9.0 Auxiliary Systems

9.1 Fuel Storage and Handling

STD DEP 9.1-1, Update of Fuel Storage and Handling Equipment (Tables 9.1-3, 9.1-4, 9.1-5, 9.1-6, 9.1-7, 9.1-8, 9.1-11, Figures 9.1-4, 9.1-5, 9.1-7, 9.1-8, 9.1-11, 9.1-12, and 9.1-14)

STP DEP T1 2.5-1, Elimination of New Fuel Storage Racks in New Fuel Vault (Table 9.1-8, Figure 9.1-14)

Figure 9.1-4 New-Fuel Inspection Stand

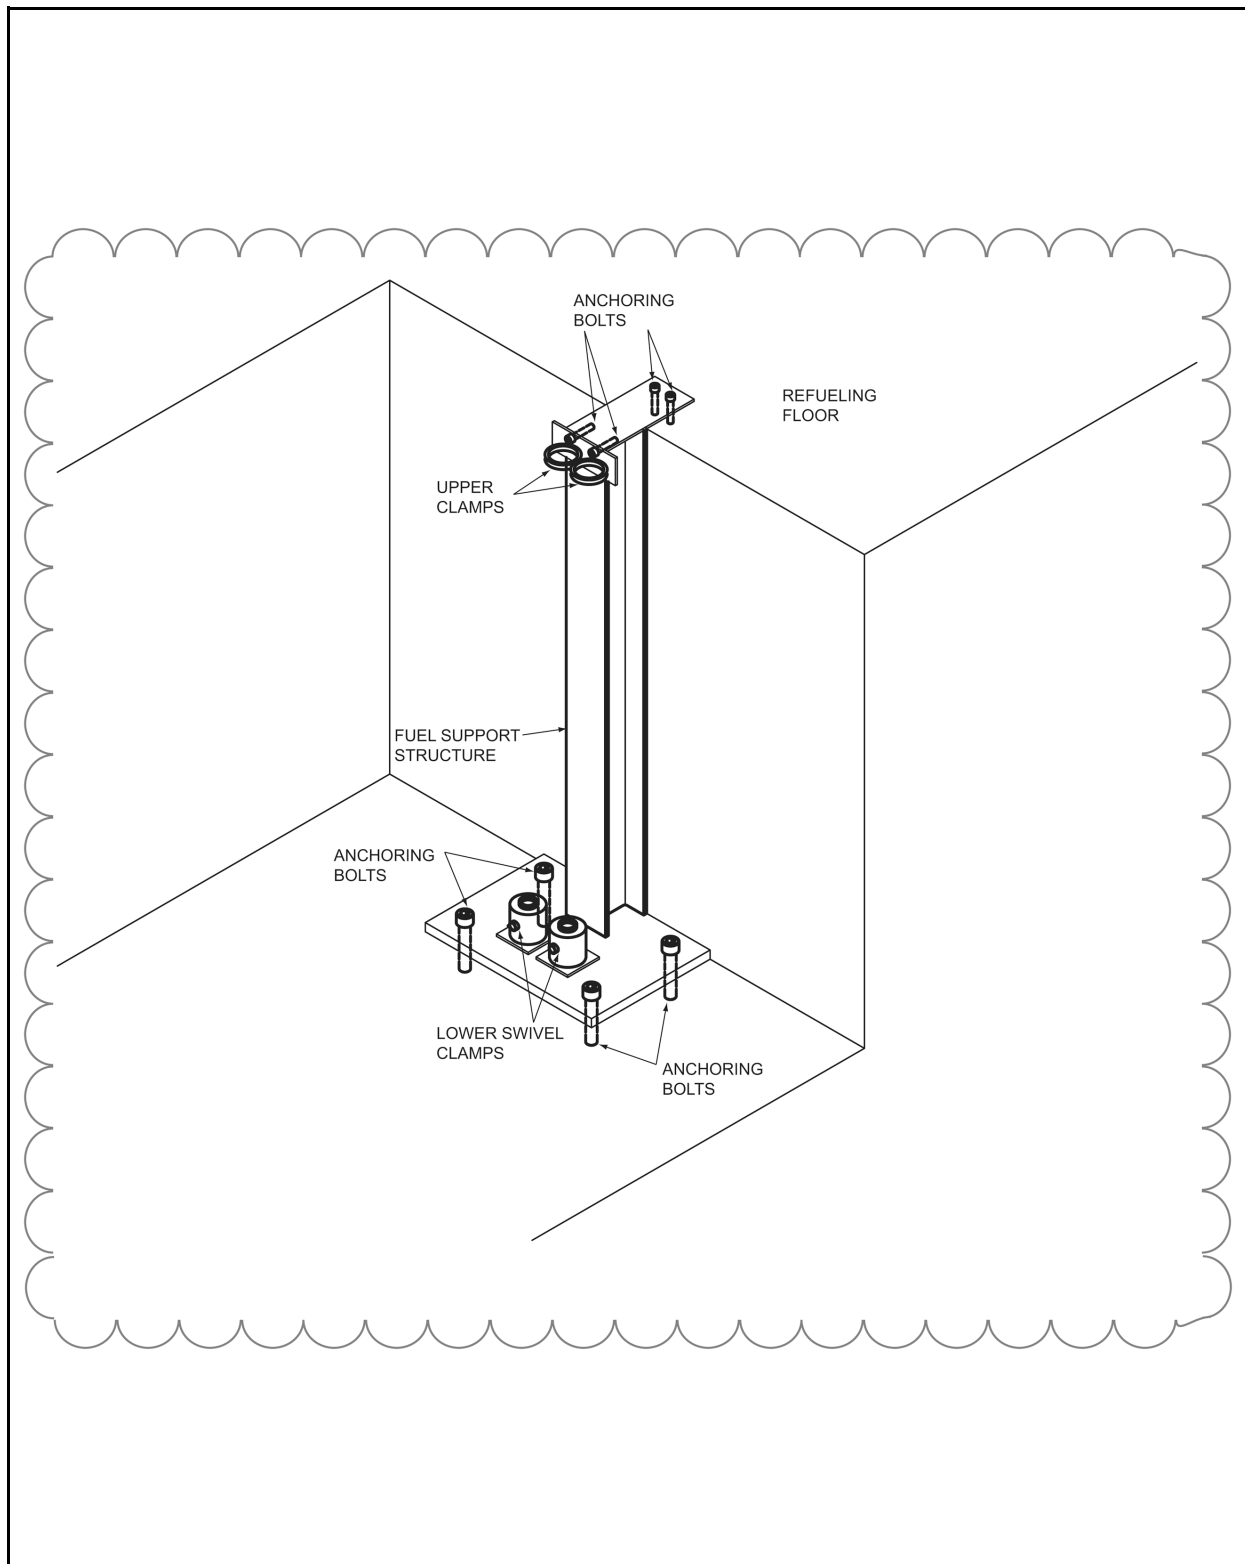
The new-fuel inspection stand (Figure 9.1-4) serves as a support for the new-fuel bundles undergoing receiving inspection ~~and provides a working platform for technicians engaged in performing the inspection.~~

Figure 9.1-5 Channel Bolt Wrench

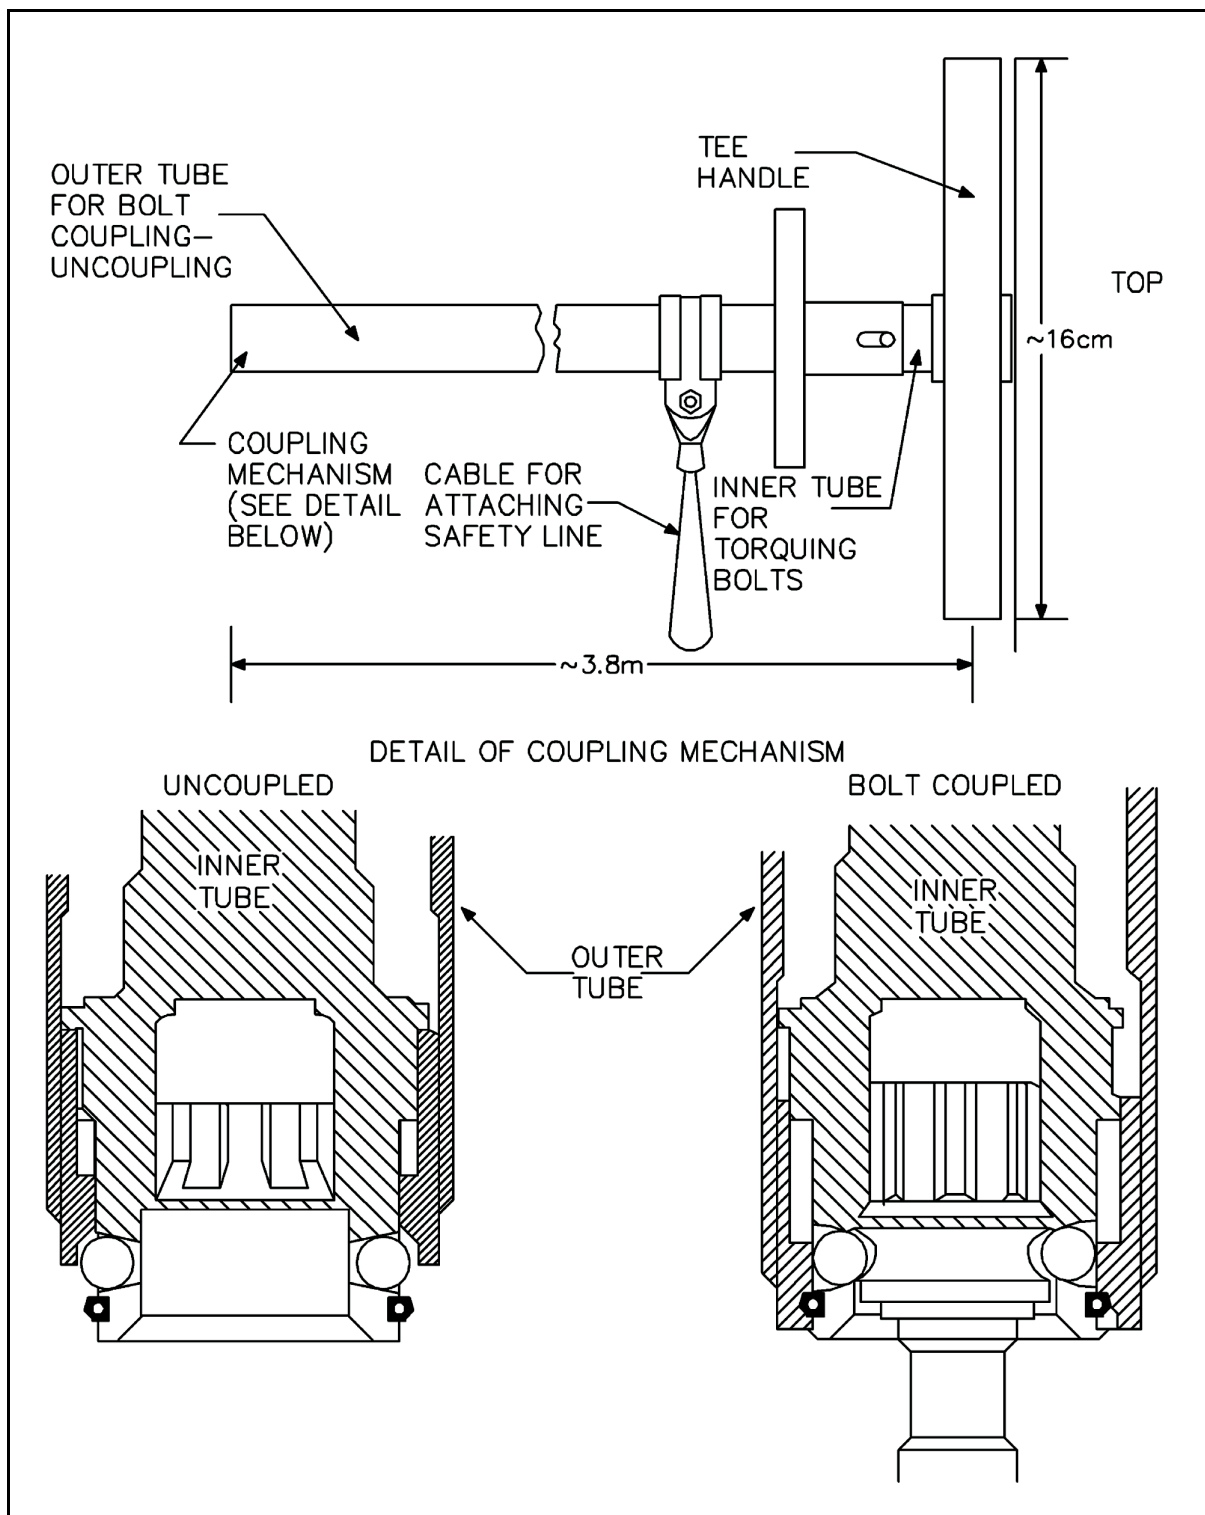
The channel bolt wrench (Figure 9.1-5) is a manually operated device approximately ~~3.76~~ 3.8m in overall length. The wrench is used for removing and installing the channel fastener assembly while the fuel assembly is held in the fuel preparation machine. The channel bolt wrench has a socket which mates and captures the channel fastener capscrew.

Figure 9.1-8 General-Purpose Grapple

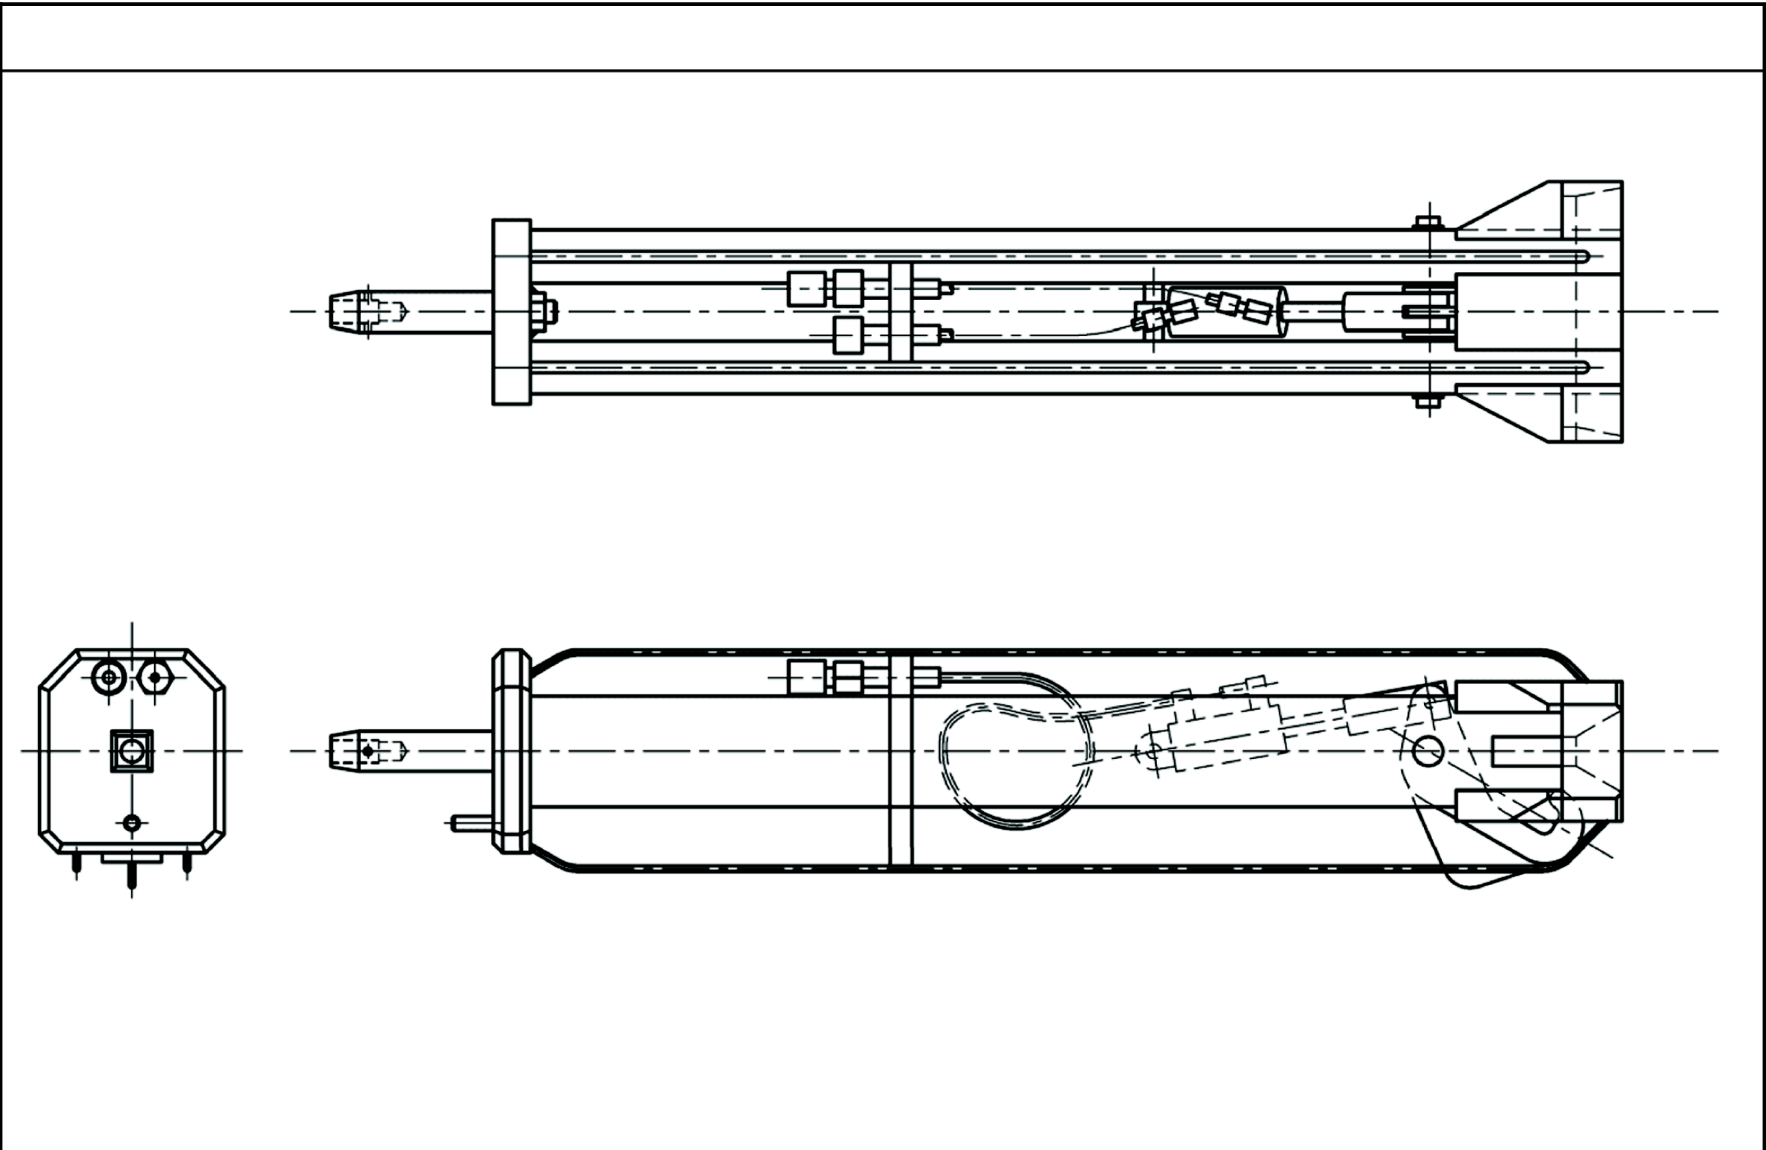
The general-purpose grapple (Figure 9.1-8) is a handling tool used generally with the fuel. The grapple can be attached to the jib crane to handle fuel during channeling, or the refueling machine auxiliary hoist.

Figure 9.1-11 Fuel Assembly Sampler Not Used

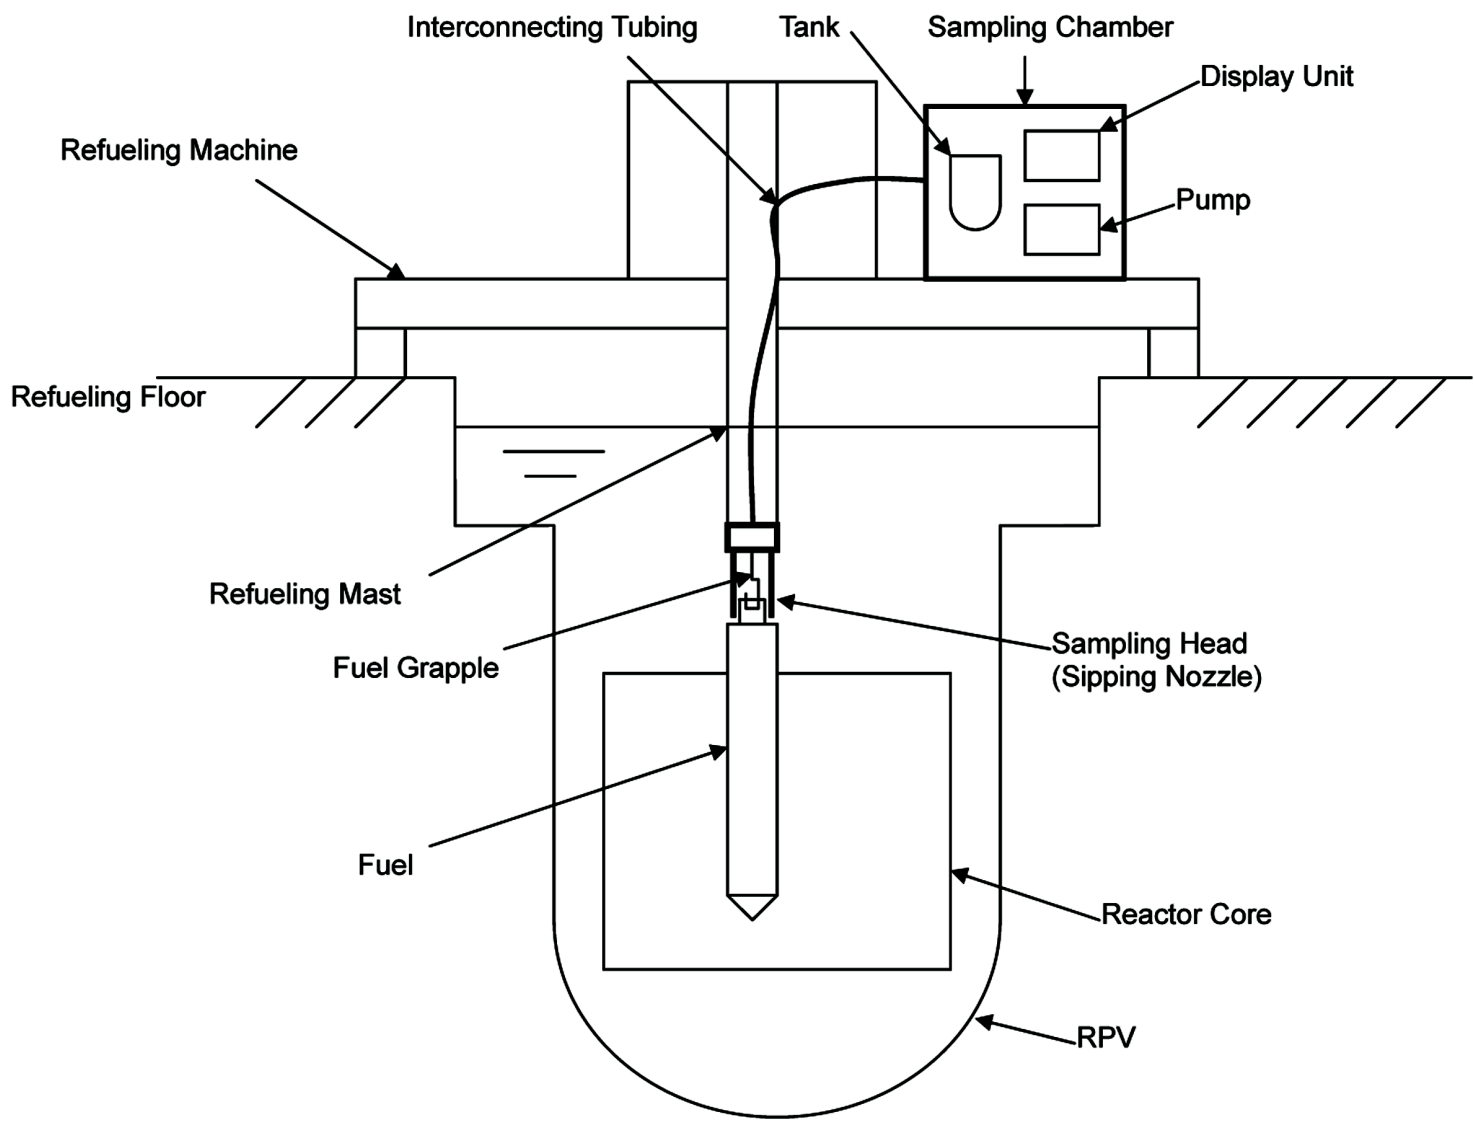
~~*The fuel assembly sampler (Figure 9.1-9) provides a means of obtaining a water sample for radiochemical analysis from fuel bundles while installed in the core. The fuel assembly sampler consists of a sampling station, two sampling chambers and interconnecting tubing. The sampling chambers are lowered over four adjacent assemblies and samples are obtained of the water in the fuel channels.*~~
